**Town of Pittsford Design Review & Historic Preservation Board
AGENDA
June 12, 2025**

**DESIGN REVIEW & HISTORIC PRESERVATION BOARD
MINUTES
MAY 22, 2025**

MEMORANDUM

Regarding: Proposed Pittsford Oaks Market Rate Apartment House (Tobey PUD Parcels 8 & 12)

1 EAST ELEVATION - LANDSCAPE
 1/16" = 1'-0"

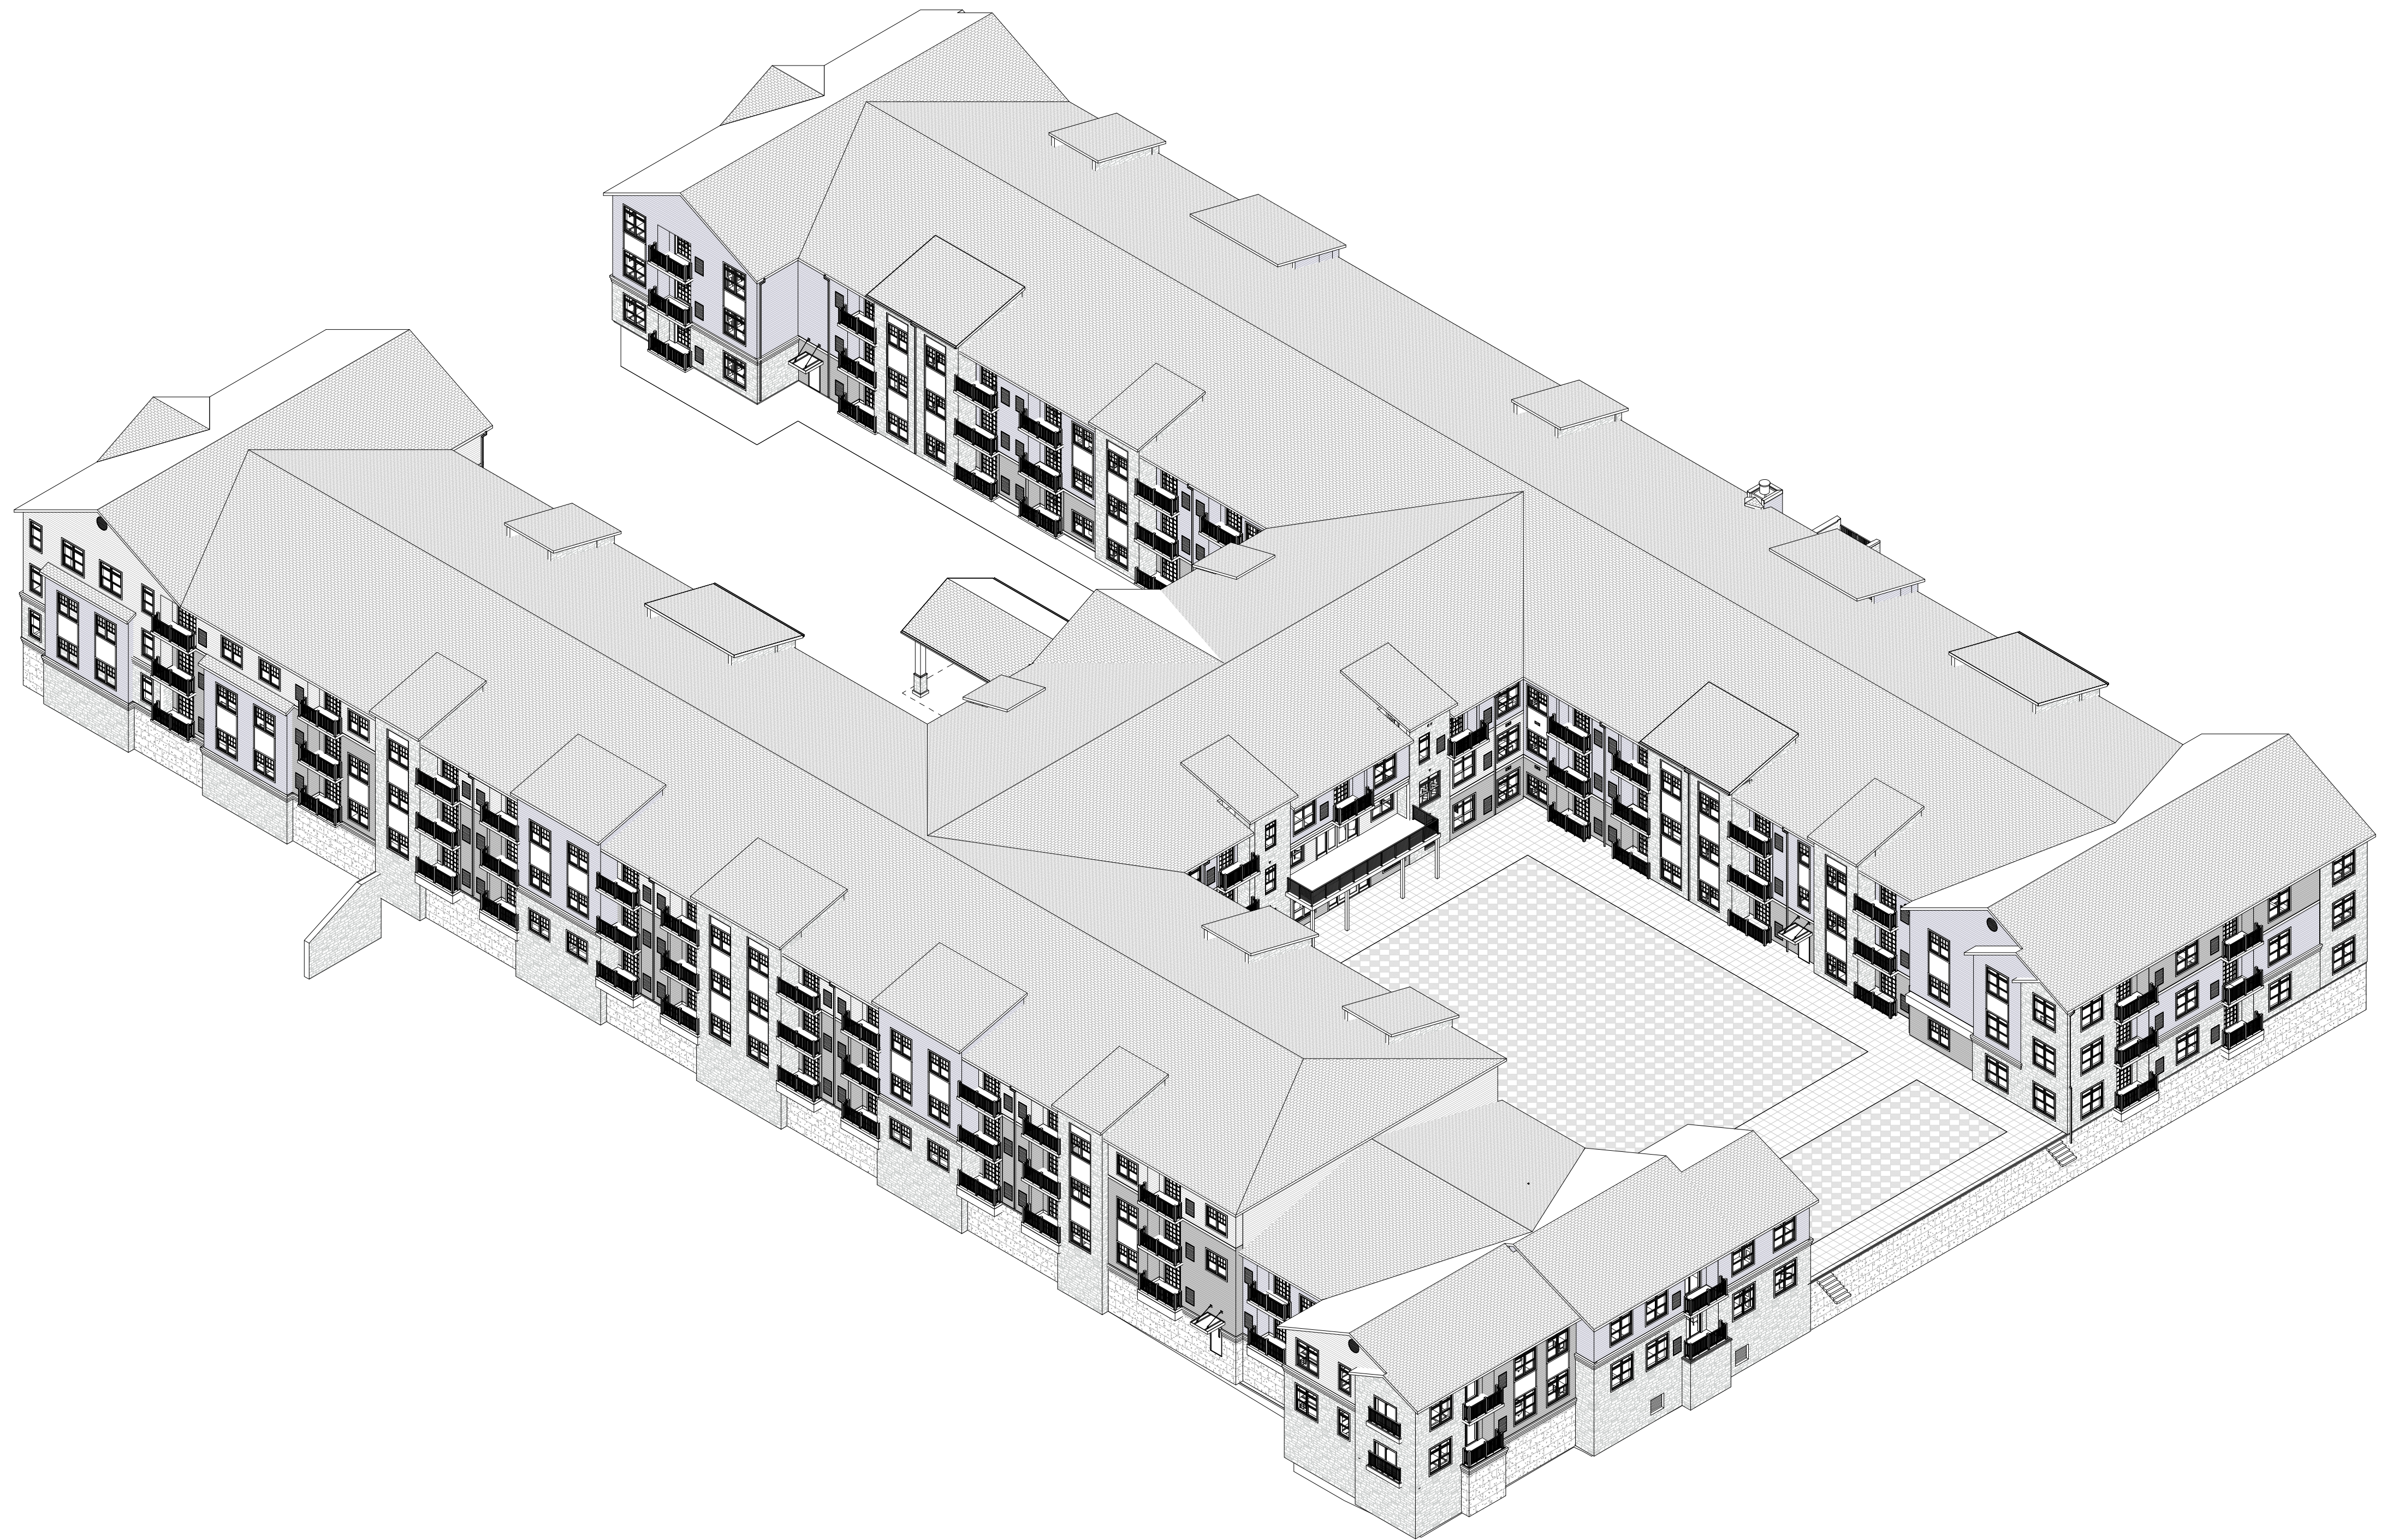
Third, as quoted above, the Planning Board has already suggested "a substantial reduction in the overall height of the eastern side of the building from behind the historic home to the northern end." Let's start with that.

Here is the suggestion: The roofline of the eastern elevation of the apartment building will mimic the Terraces at Cloverwood eastern elevation. The northeast leg will be reduced to the same u.s.g.s. roof elevation (571 feet) as the Terraces at Cloverwood design for a distance of 155 feet, which equals the same percentage of lowered roof as the Terraces at Cloverwood design. The remaining roofline going south will be similar to the height change of the Terraces at Cloverwood design, which is ± 10 feet. This will create a significant break in the roofline and will simulate the massing of the Terraces at Cloverwood project as viewed from the Clover and W. Jefferson intersection and from directly east of the project on Clover Street.
